Title: Relocation of Receiver Air-con exhaust fans

16 Production Receivers at the MRO

FIGURE 1: EXHAUST FAN MOUNTED TO AIR-CON SKID VIA NEW BRACKETS.

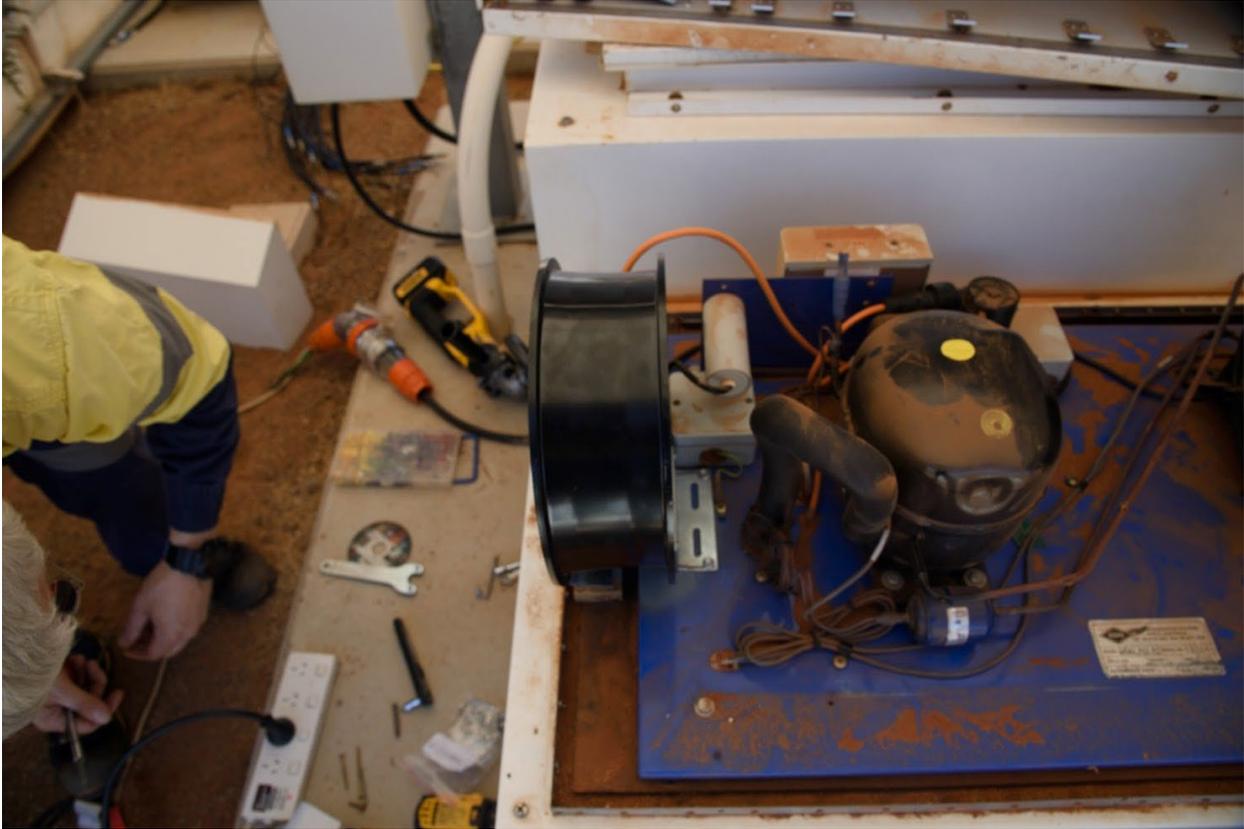
In order to improve air-conditioner serviceability, in particular for periodic fan replacements to pre-empt motor failures, we had the GCo crew re-locate the air-con exhaust fans from the covers, to the main air-con "skid", during the first run of pre-emptive fan motor replacements conducted during the Feb site trip. We also fitted crimp terminals on the power cables instead of the previous soldered connections.

Relocating the exhaust fan onto the air-con skid meant that the power cable could be permanently routed to avoid fouling the cover or other air-conditioner components. Furthermore, due to changing from soldered to crimp terminal connections, the fans can be replaced in the future without the need to solder in the field.
